SITE DEVELOPMENT PLAN

LOT 2 - CLAREMONT BUSINESS PARK 2 FILING NO. 2
 A PARCEL OF LAND IN THE SOUTHEAST QUARTER OF THE SOUTHEAST QUARTER (SE ¼ SE ¼) OF SECTION 5,
 AND THE NORTHEAST QUARTER OF THE NORTHEAST QUARTER (NE ¼ NE ¼) OF SECTION 8,
 T14S, R65W, OF THE 6th P.M., EL PASO COUNTY, COLORADO

LOT 2 - CLAREMONT BUSINESS PARK 2 FILING NO. 2
 SITE DEVELOPMENT PLAN
 JOB NO. 10-025
 DATE PREPARED: 09/20/23
 DATE REVISED:

FILE NUMBER: PPR2345

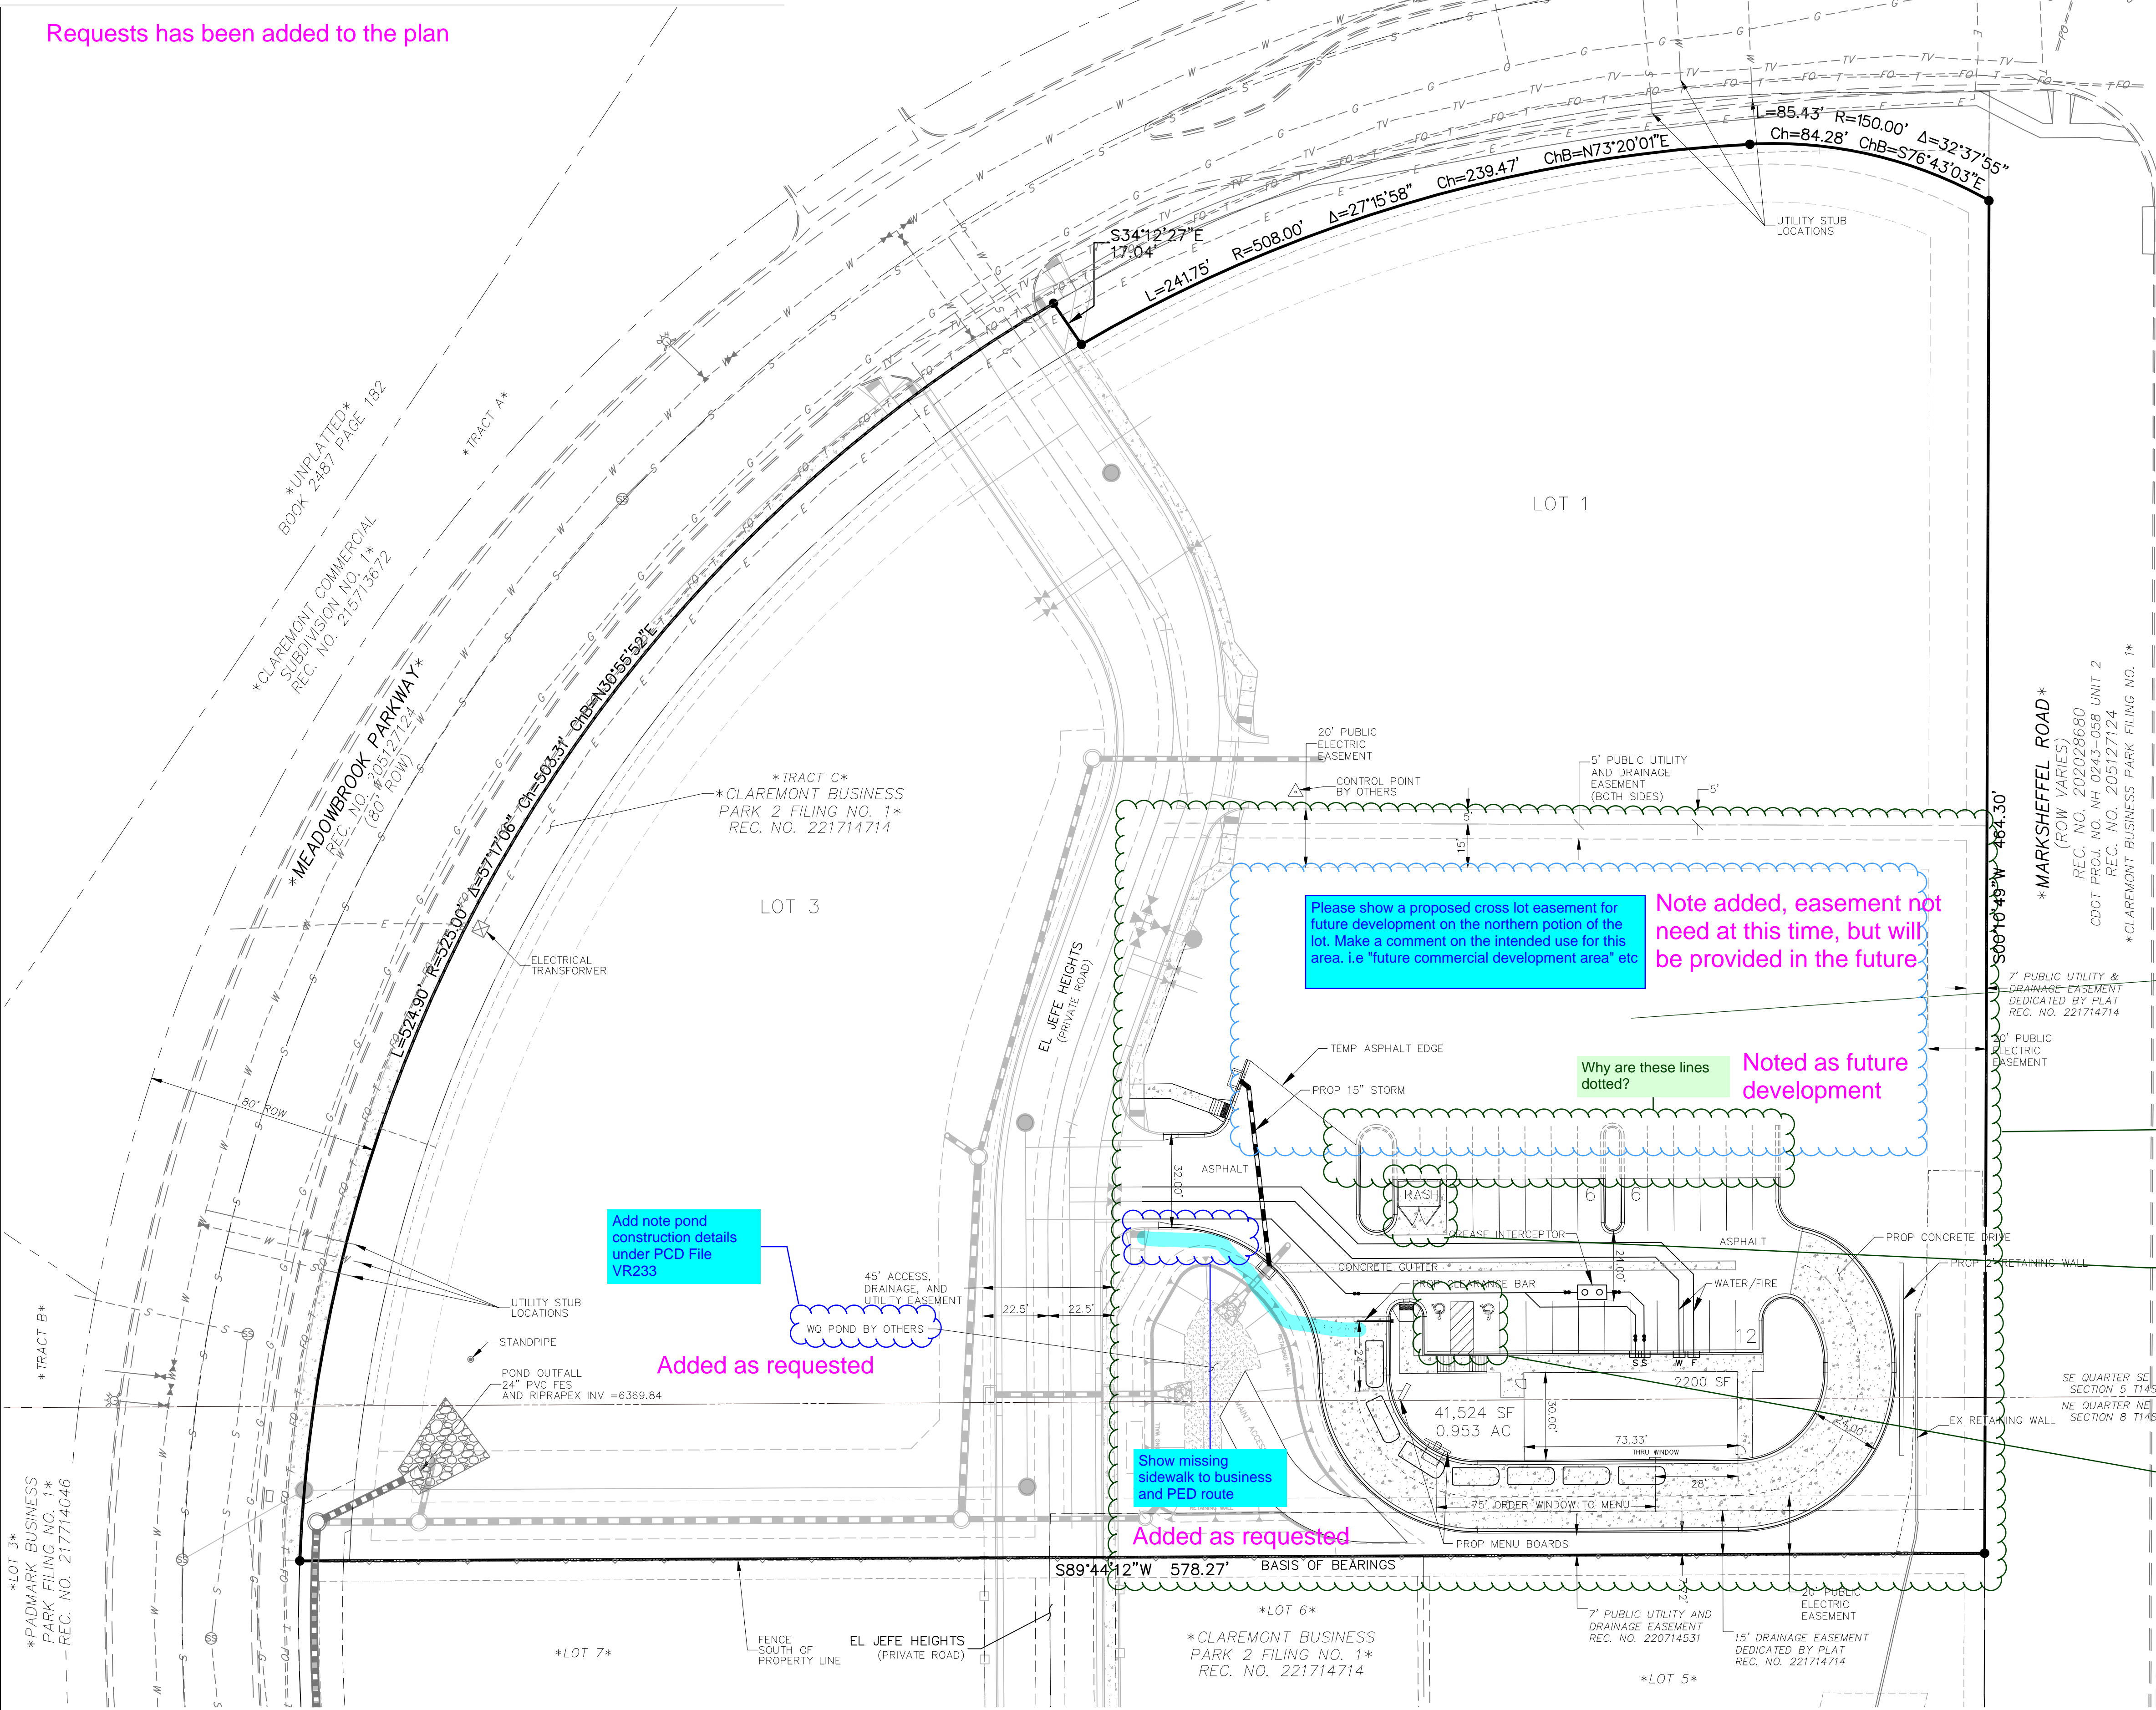
Please provide:

- property address
- parcel number
- current zoning
- lot size

- Lot area coverage calculation
- Existing/proposed land use and zoning
- Total gross building square footage
- Open space, landscaping, and impermeable surface percentage
- A note stating: The owner agrees on behalf of him/herself and any developer or builder successors and assigns that Subdivider and/or said successors and assigns shall be required to pay traffic impact fees in accordance with the El Paso County Road Impact Fee Program Resolution (Resolution No. 19-471), or any amendments thereto, at or prior to the time of building permit submittals. The fee obligation, if not paid at final plat recording, shall be documented on all sales documents and on plat notes to ensure that a title search would find the fee obligation before sale of the property.

Please provide:

- setback distances from buildings to ALL property lines
- dimensions of all property lines
- Signature block for the Planning and Community Development Director a minimum of 1 inch by 2 inches
- Location of all sidewalks, trails, fences and walls, retaining walls, or berms
- Location and dimensions of all existing and proposed signage on site
- Traffic circulation on site including all points of ingress/egress into the property
- The layout and location of all off-street parking, loading and other vehicular use areas, unless otherwise depicted in detail on a separate parking plan. If depicted on a separate parking plan then depiction of the parking areas are required.

Please show a proposed cross lot easement for future development on the northern portion of the lot. Make a comment on the intended use for this area. i.e. "future commercial development area" etc

Why are these lines dotted?
 Noted as future development

Add note pond construction details under PCD File VR233

Show missing sidewalk to business and PED route

Label Lot 2
 Added as requested

Please depict any floodplains or no-build areas, if none, then specify

What screening is provided?
 Please depict or show on separate page the type of screening and height

Are there ADA signs?
 Please depict or show on a separate plan

Please provide:
 -parking space dimensions
 -parking table for required vs provided
 -bicycle space required, 5% of provided parking spaces

Requests has been added to the plan

Requests has been added to the plan

Note added, easement not need at this time, but will be provided in the future

Added as requested

Added as requested

Note added, on plan

Note added, to see architectural plans for trash enclosure details

Detailed added to plan

Table added has been added to the plan
